ZOSTRICH GEOTECHNICAL

RE: REVIEW OF NANISIVIK MINE OPENINGS CLOSURE PLAN (JANUARY 27, 2005)

PROJECT: NANISIVIK ROCK MECHANICS REVIEW - III

From Figure 28, Underground mine plan

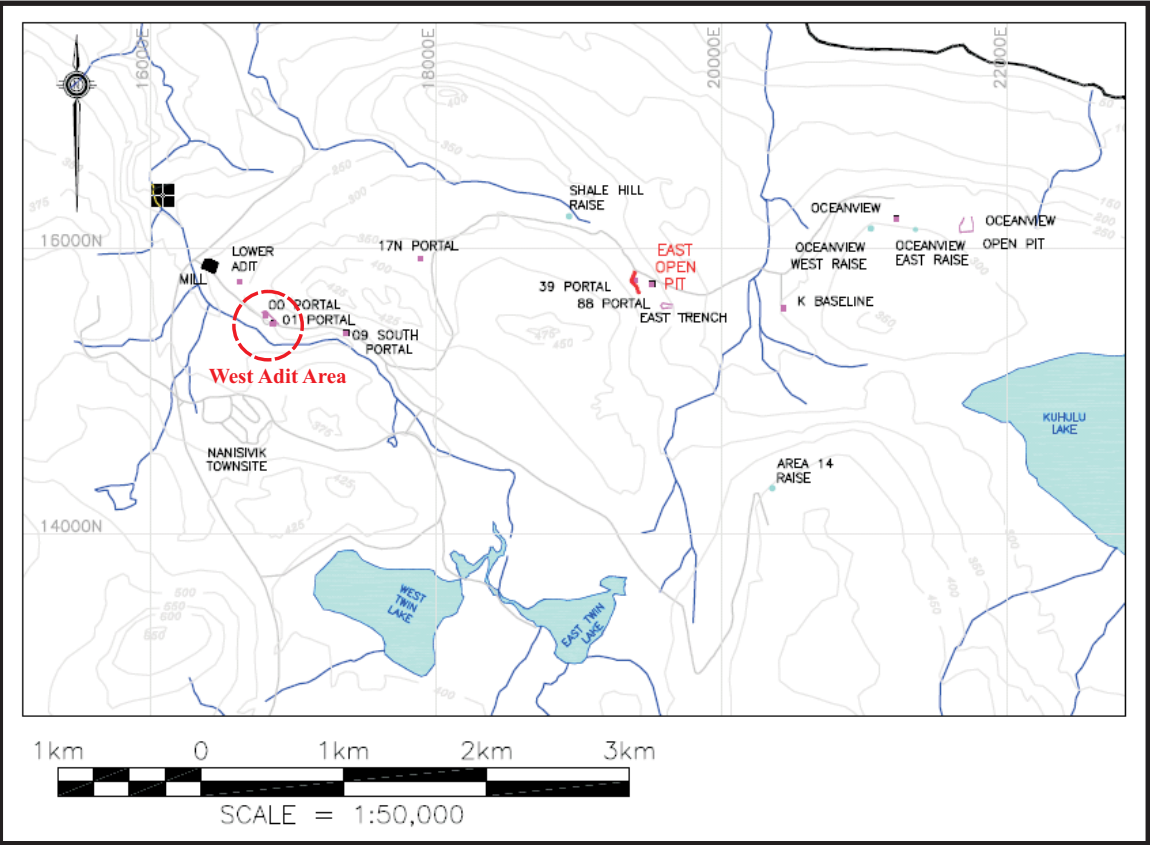
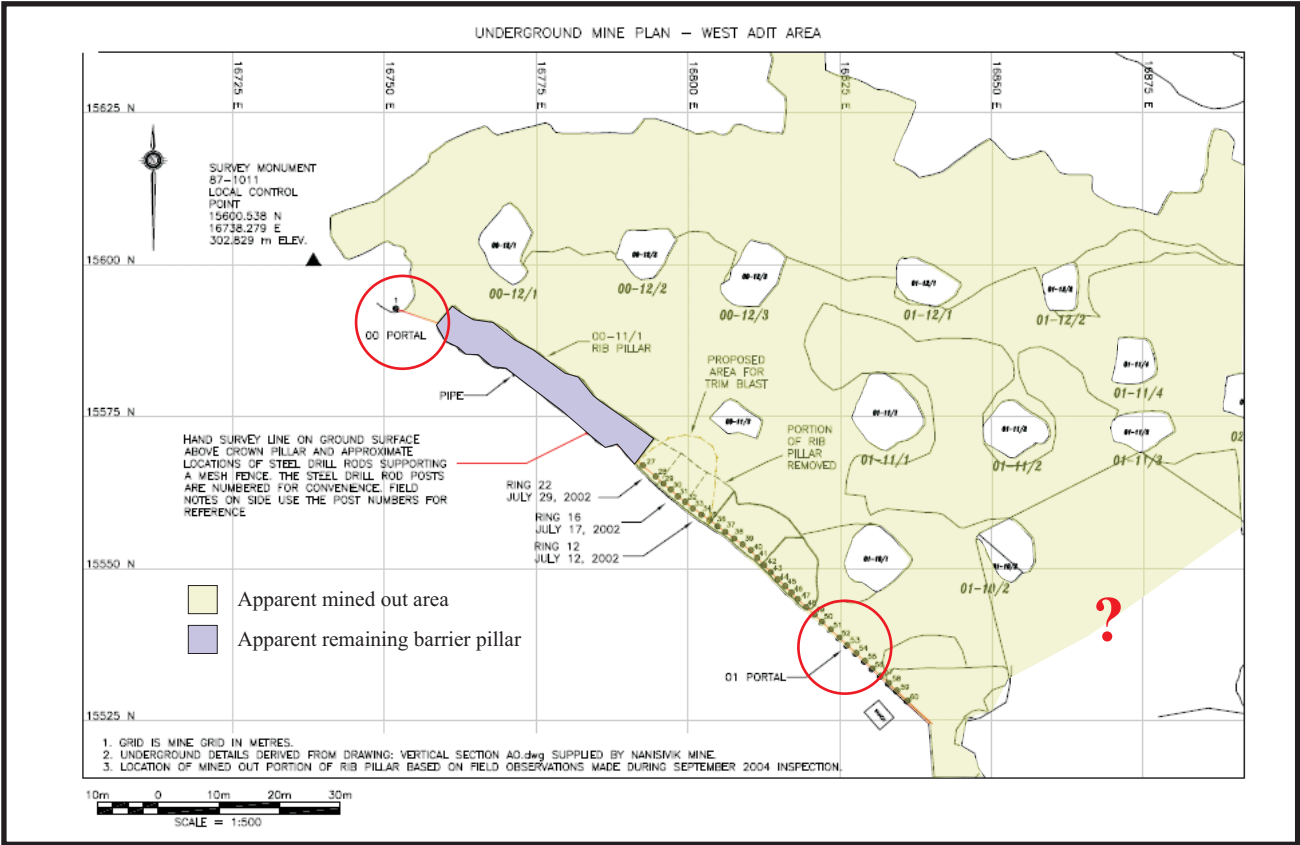
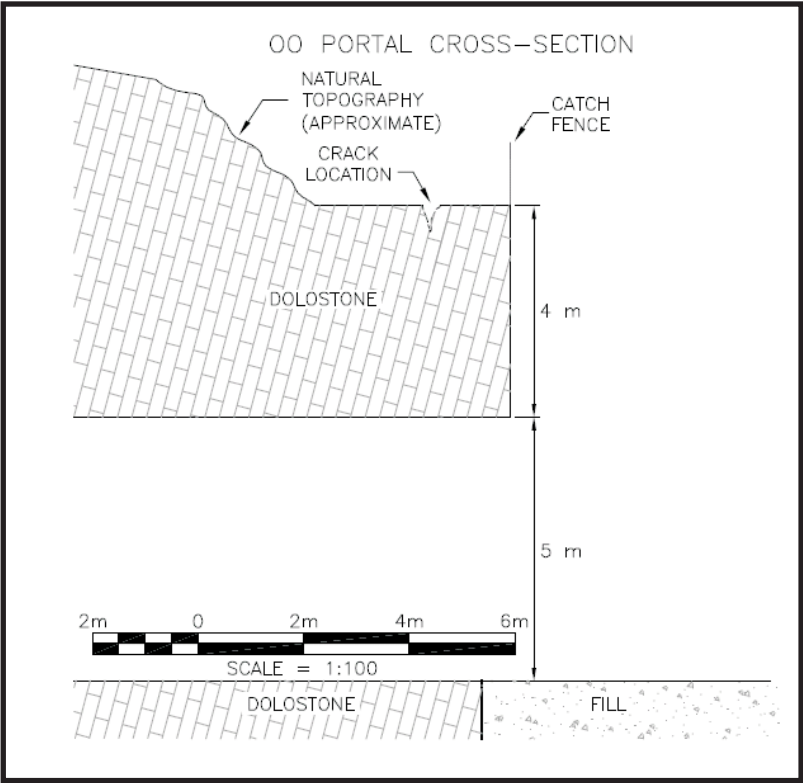
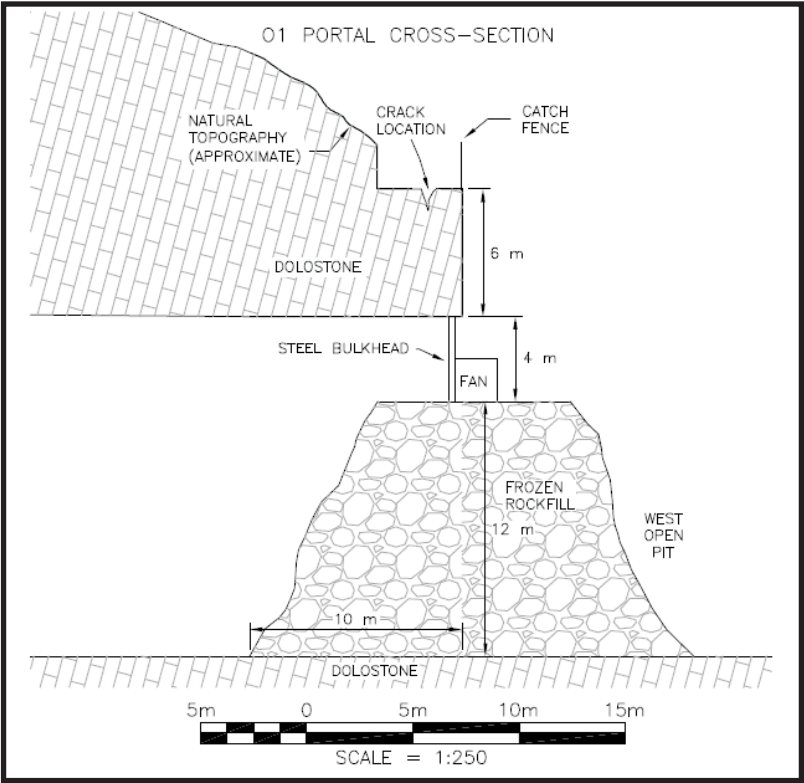
As for the East pit, one cannot discern the geometry from the shown mine plan (Figure C). A detailed mine plan is required, including elevations as well as opening heights. Such has not been presented. This pit/underground interaction area is complex as well. In this case, a rib pillar against the West pit highwall was apparently blasted out. How much is unknown. A failure now exists paralleling the highwall. This has been attributed to toppling. Remedial work has been proposed in the form of blasting down the highwall in a specific area, then pushing muck underneath the daylighted brow for a very limited distance.

What has been presented is explained insufficiently and does not appear to be founded on a detailed engineering study of the situation. The present evaluation (Lauzier, 2002), indicating that if a 5m “brow” remains between surface and the opening, it will be stable is obviously in error as the brow is failing here at a 5m thickness or greater.

First, in the upper right diagram above, it is unclear what is mined, what remains, where the pillars are located, what portion of the barrier pillar has been mined, etc. This is insufficient. Neither planning and analysis, nor review, can be conducted on drawings of this nature.

Sections are shown to the left indicating the apparent dimensions, failure mechanisms, etc. of the area. These, too, are incomplete in terms of present rock support, expectations of failure progression, engineering analysis, and final remediation.

In a situation such as this, with overhanging rock, viable kinematic failure mechanisms, frost and water action potentially driving such mechanisms, blast damage, etc, a detailed engineering stability analysis is warranted, as is a specific detailed monitoring plan. Visual assessment is insufficient.

A detailed engineering analysis is required for this area. This will require that the geologic structure, mine openings, and surface topography of the entire area be accurately known and provided to the designer. In addition, the designer should expend more time and effort in understanding the failure mechanisms in play, as well as the effect of frost action, water, and present rock support degradation.

If backfill is to be an option, it should adequately support the brow and immediate area. Uncemented fill will likely not fulfil this purpose as it will compact. In addition, as these are large openings, shown as being greater than 10m in height, appropriate care should be taken to include this aspect in closure design.

VIEW OF 17 NORTH PORTAL (SEPTEMBER 2002).

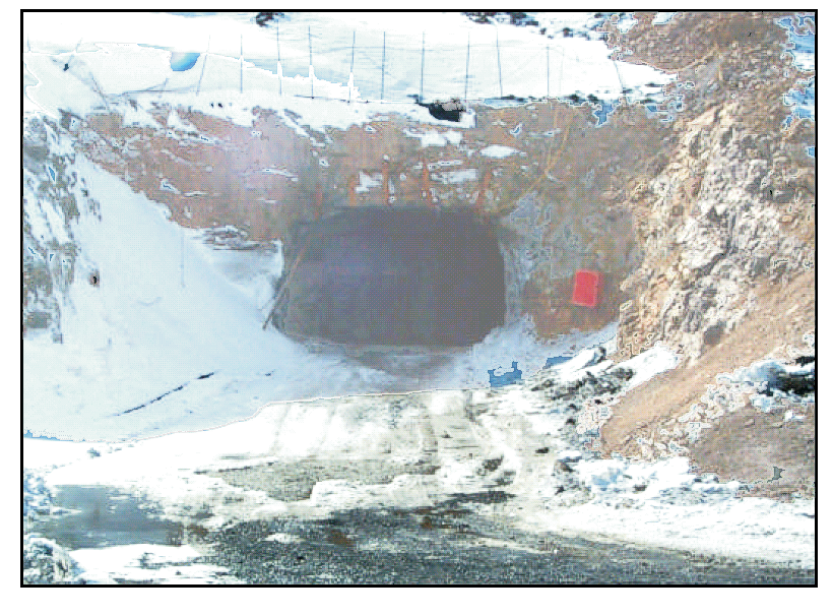
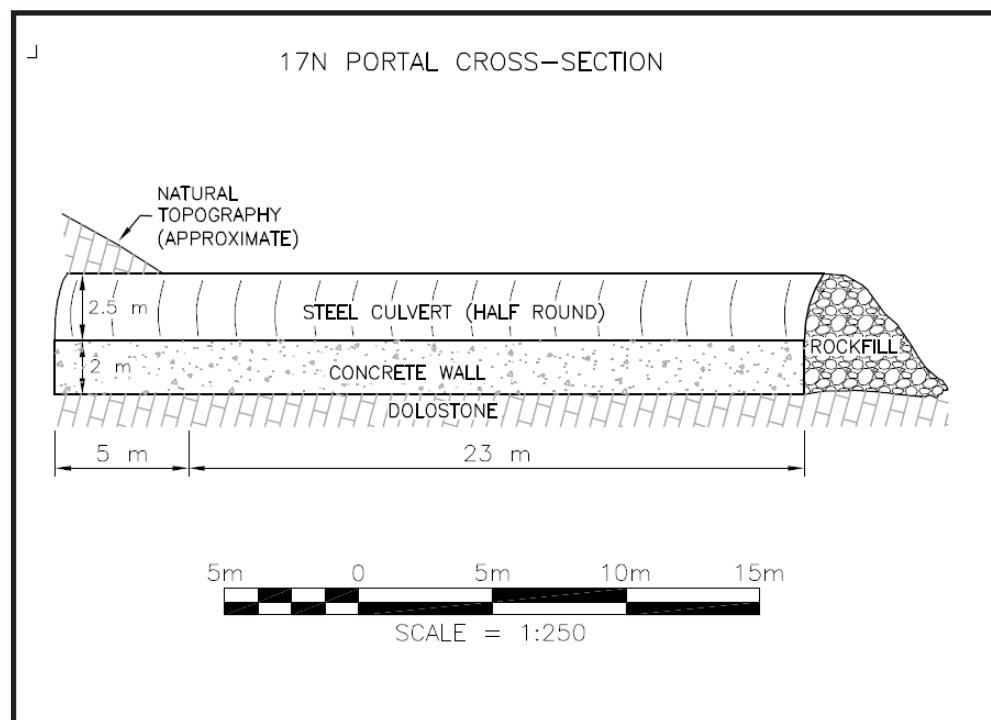
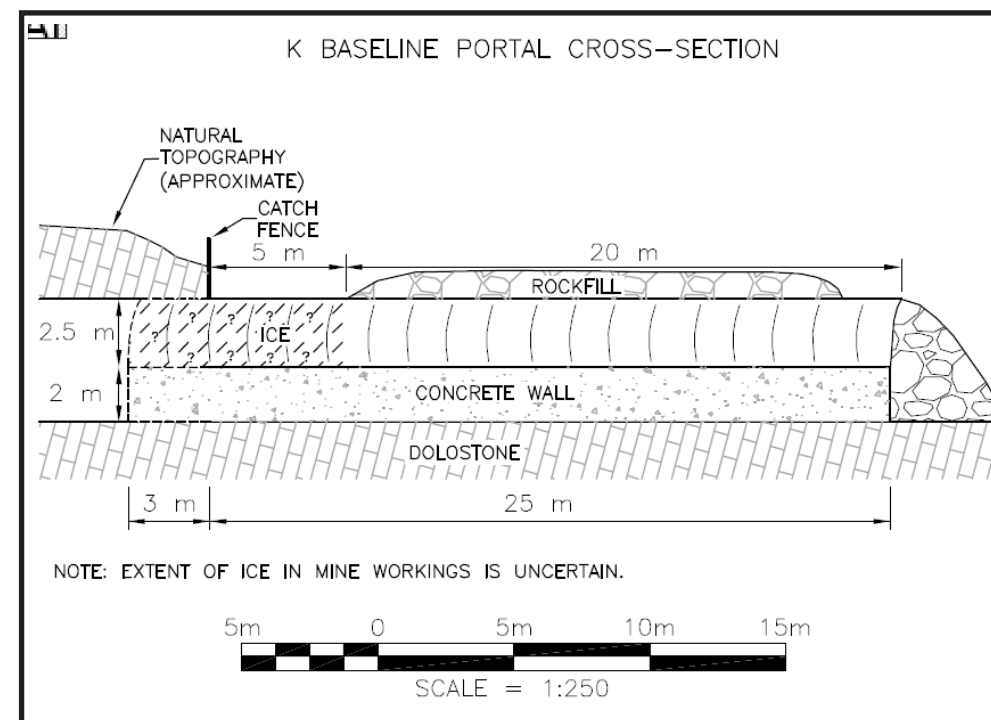
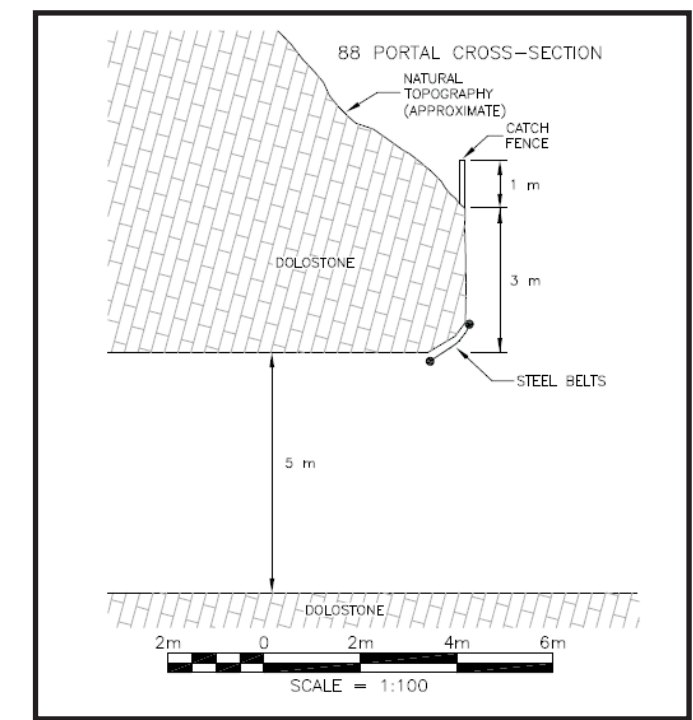
These designs are insufficient as they do not quantify the cover, potential failure modes/geometries, and the degradation of presently installed rock support.

As can be seen in Figure D, these portals are located in areas of low relief. They obviously have some cover, but the liners (“culvert”) would not have been utilized if adequate cover could have been quickly attained when driving the openings.

The topography and geologic structure for this area are uncertain. However, it is noted that strap (“steel belts”, Figure D) has been utilized to wrap the brow (photo, Figure D). This is normally done when it appears that rock blocks can fall from the brow.

First, all of the shown portals appear to have relatively shallow cover (from photographs) for quite some depth into the rock mass. This lack of cover is not shown in the provided sections, nor are the geologic structure and associated failure modes shown.

In addition, ice is not generally approved as a permanent backfill material.

In general, detailed engineering design, including adequate geologic sections, failure modes, and provided permanent rock support has not been provided.

Detailed analysis is required. In addition, ice is not considered adequate backfill material. Rockfill, if utilized, must be jammed to the back in the areas where subsidence could occur, as identified by the aforementioned analysis.

Therefore, a detailed engineering analysis is required, showing the geologic structure, accurate topography, and an accurate depiction of the portal face and alignment to some depth at which failure is shown to be improbable. The reasons for the straps, and the effect of the degradation of the presently installed rock support should be included in this analysis as well.

VIEW OF SHALE HILL RAISE (PRE SEPTEMBER 2002).

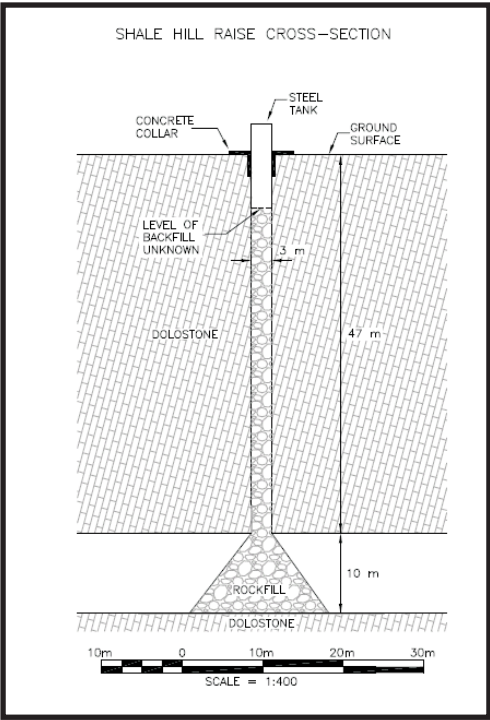
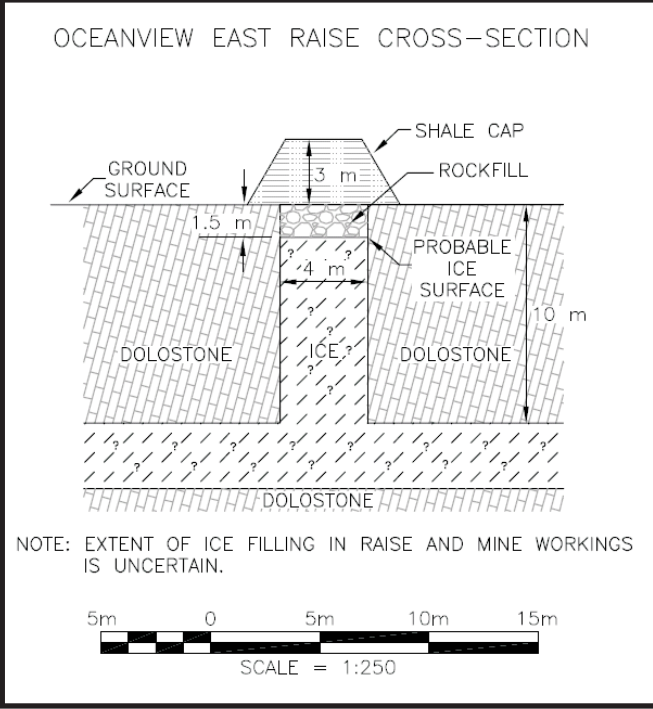
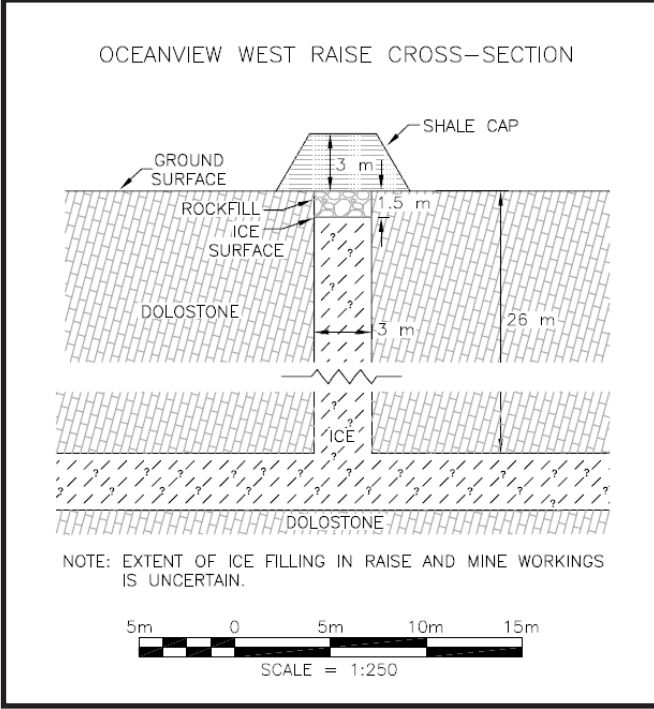
In many cases, as is demonstrated in Figure E, the raises are presently blocked with ice. While backfill may have been placed in these raises, it is uncertain what depth the rock fill has attained.

Backfilling on top of these ice blockages, especially when they are close to the collar (surface) is inappropriate. Ice can settle and creep or the ice bridge may be narrow and fail resulting in surface subsidence and/or an open hole.

First, it is apparent from all the shown sections that the raises are blocked with ice. Even if rock fill has been placed in the raise, it is uncertain to what depth the fill is found.

This is inadequate as Ice is not generally approved as a permanent backfill material.

The raises should be sealed with an engineered concrete plug or the ice removed and the rock fill verified for the depth of the raise. Alternatively, other potential engineered alternatives may exist.

In this case, if the depth to the rock fill is unknown, then a permanent concrete plug should be placed at the raise collar. The thickness of this plug is the responsibility of the design engineer.
